[Upgrade to Revision]

R20TS0771EJ0100

RH850 Model-Based Development Environment,  
 Embedded Target for RH850 Multicore + Multirate V5.02.00,  
 Embedded Target for RH850 Multicore V5.02.00,  
 Embedded Target for RH850 V5.02.00

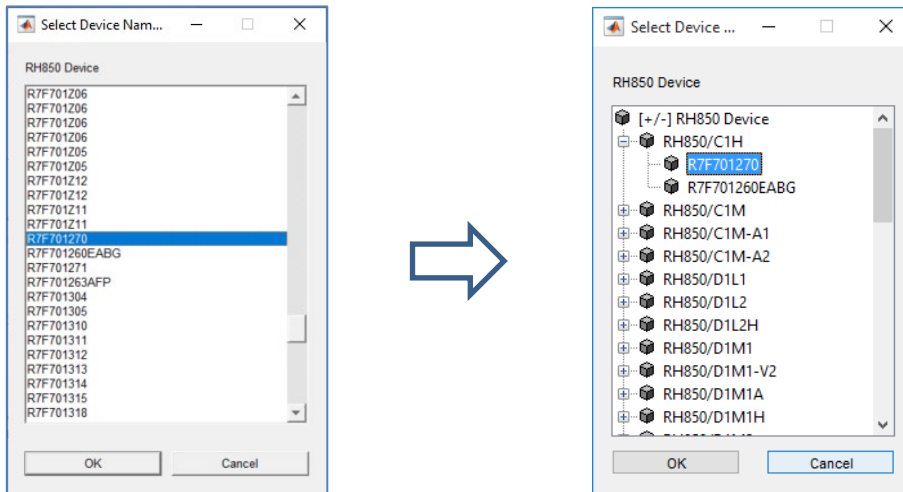
The main changes are as follows.
